## TOWN OF YORKTOWN PLANNING BOARD

### PUBLIC MEETING AGENDA VIDEO CONFERENCE

March 8, 2021

**TREE MITIGATION PLAN**

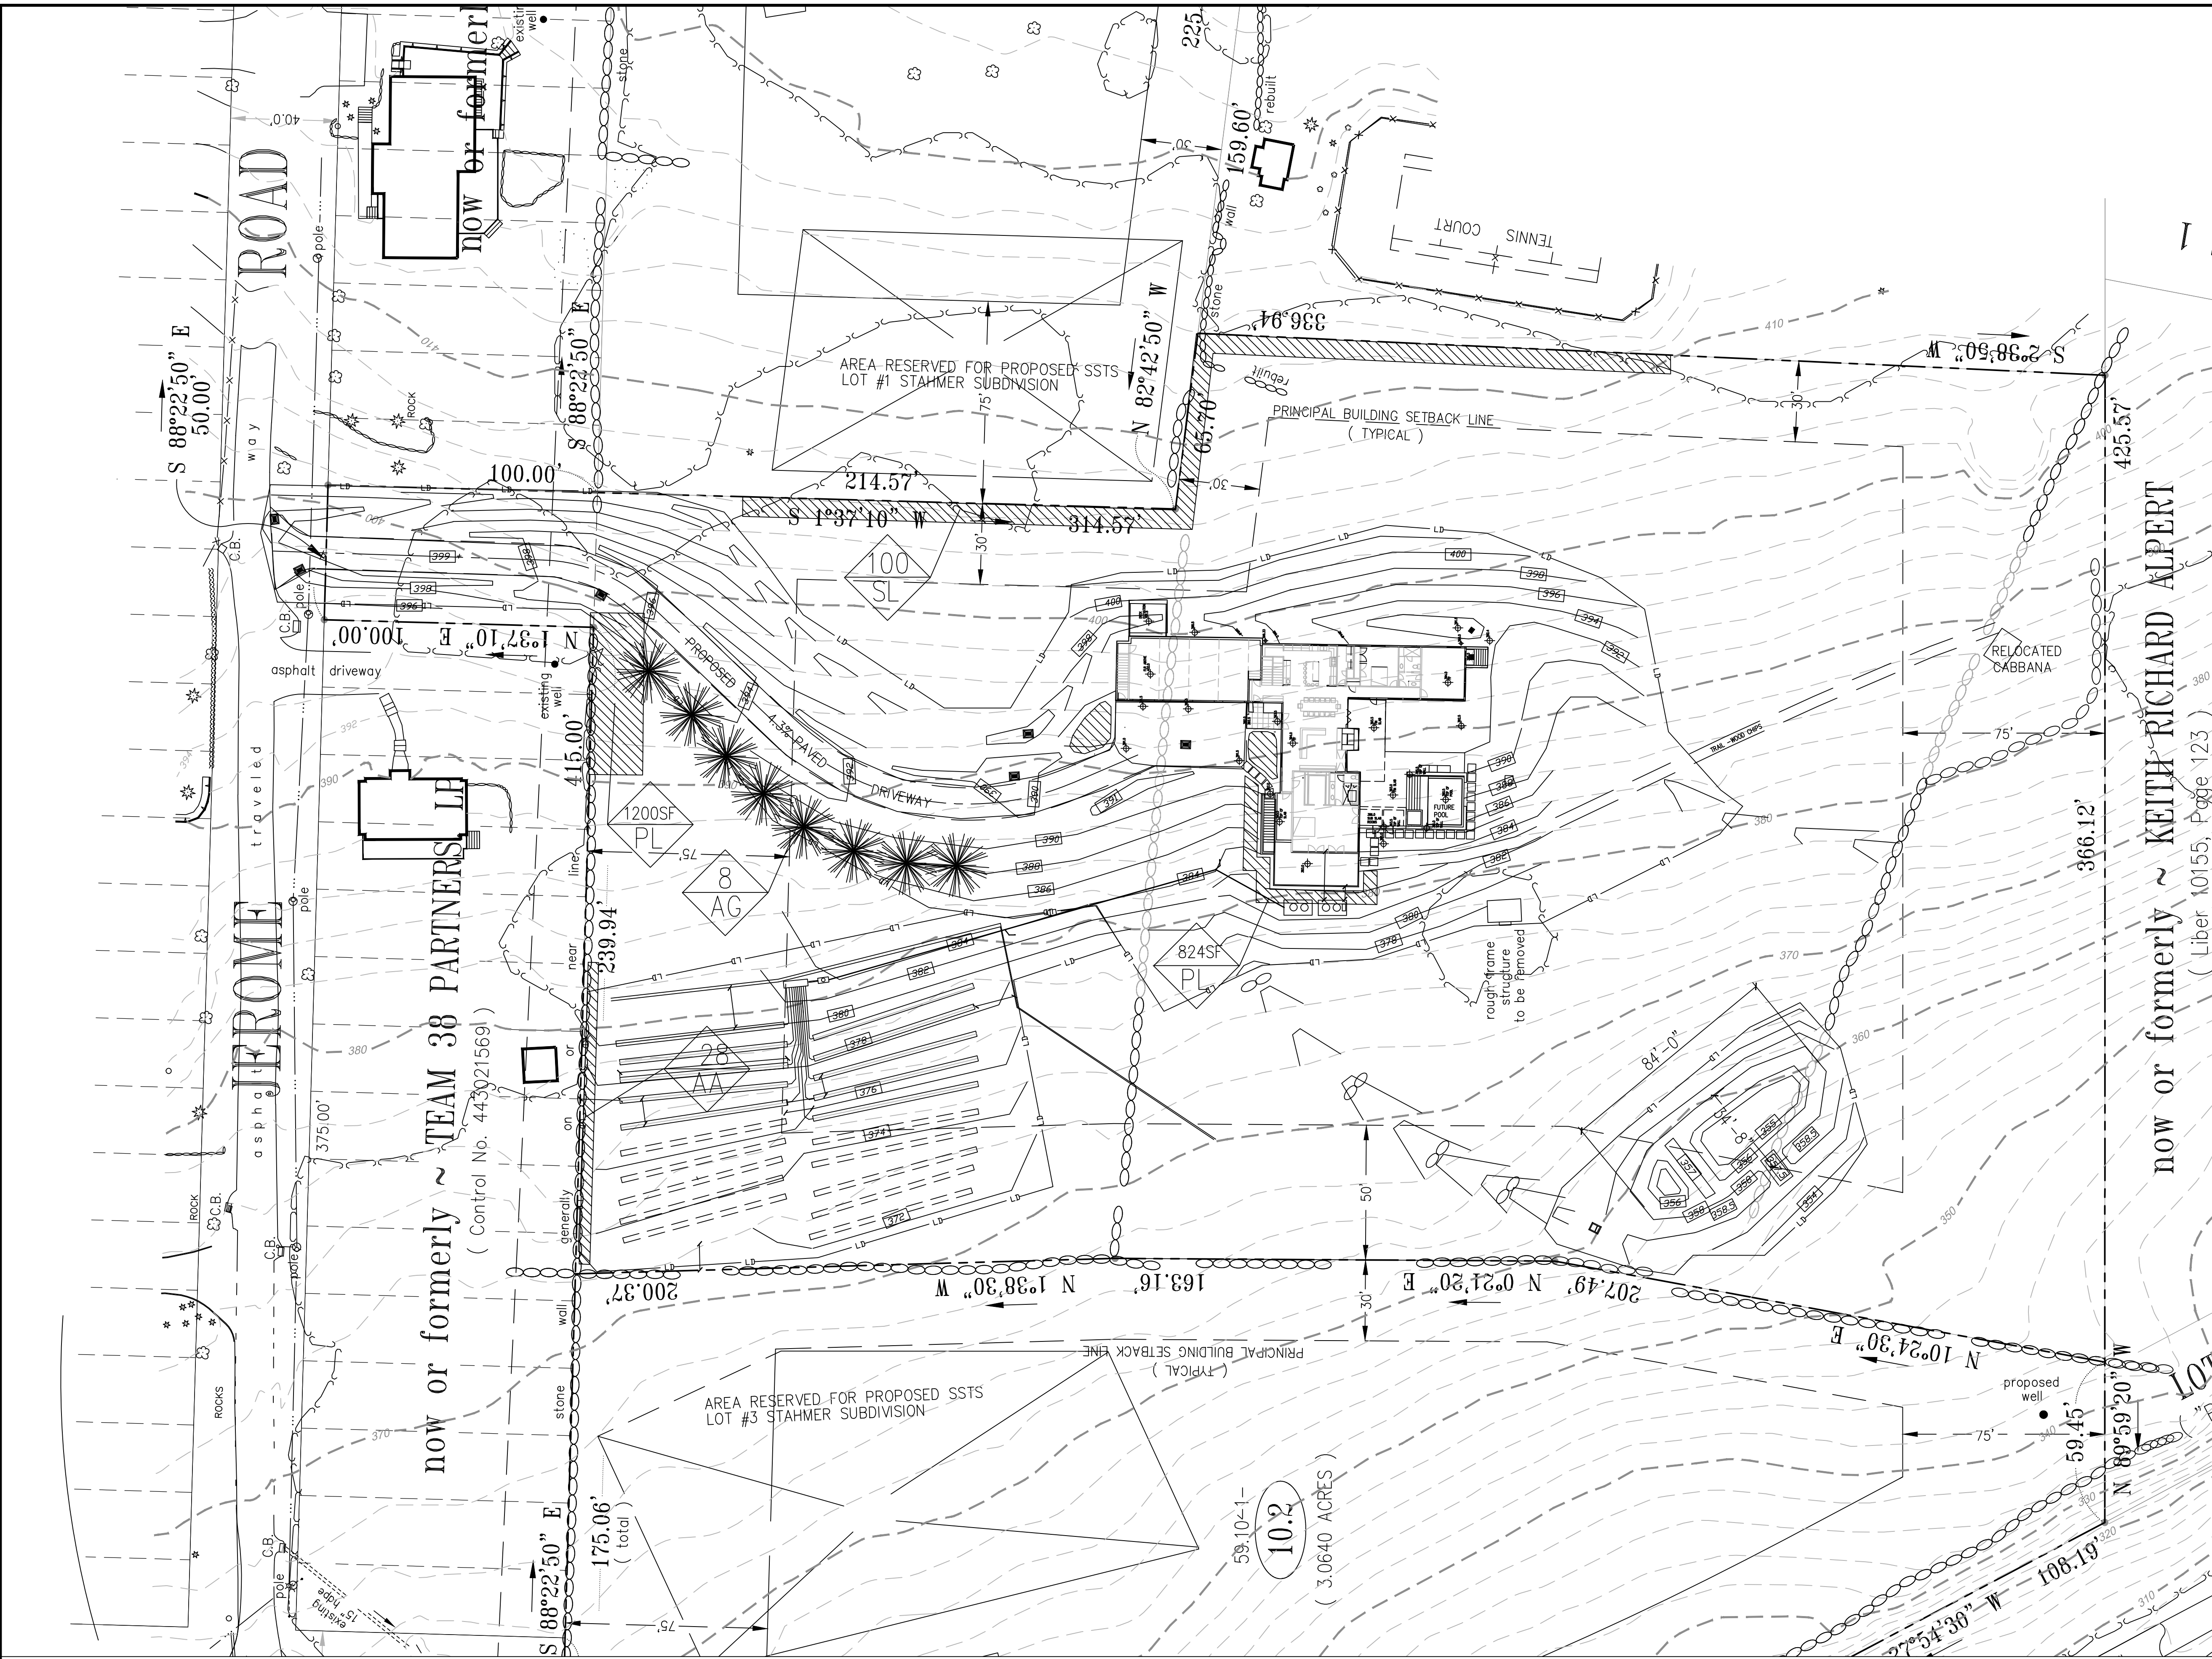
Please refer to drawing SY4 Tree Plan for the following discussion.  
The expansion of the house footprint impacted 30 trees as is marked on the pdf with a red cross. The list of dbh for each tree is tabulated on the attached page.  
The total tree impact: 330 (dbh x tree number) for the house expansion.

Refer to the Tree Mitigation Plan, SY4A

- II) Installation of a buffer along the east property line  
 Species: Skip Laurel: Prunus Laurocoraus: 10'-18' tall, 5'-7' wide  
 For size comparison, purchased at 3-4 ft tall planted at 4' oc for buffer  
 Mitigation: 2400 sf. At 4'oc this equates to  $400lf / 4 = 100 \text{ trees} @ 2'' = 200 \text{ dbh}$
- III) Installation of tree buffer along the west side of the driveway, blocking the view of the house from the neighbors to the north along Jerome  
 Species: Arborvitae: Green Giant; size: 50-60 tall, 10'-20', wide

The intent is to have each tree independent, so the conical shape is clearly defined along the driveway. The planting spacing is at 20' on center, which when viewed from the north will form a buffer.  
 Mitigation:  $8 \times 3'' = 24 \text{ dbh}$  (at full growth: 24'' dbh each)
- IV) Installation of tree buffer on the north property line along the edge of the septic system which is within 10' of the property line  
 Species: Arborvitae: Black American; size: 20-30' tall, 4-5' wide, plant at 4' oc.  
 Mitigation: 440 sf. At 4'oc this equates to:  $112lf / 4'oc = 28 \text{ trees} @ 2'' = 56 \text{ dbh}$
- V) Landscape planting along the residence

While not yet determined, the house shall have extensive plantings along the north, west and south faces. The planting beds shall measure 5' from the roof drip line and extend along the face of the building.

This area is equal to a total of: 824 sf of planting beds as noted on the plans.

This plan provides visual buffers to the neighboring house sites. The owner purchased the lot to the west as a buffer and which will remain as a forested site until a house is constructed, at which time the project shall be submitted for a tree permit and review of the proposed buffers to the west. Please refer to drawing SY4A for the location of the specific plants noted above.
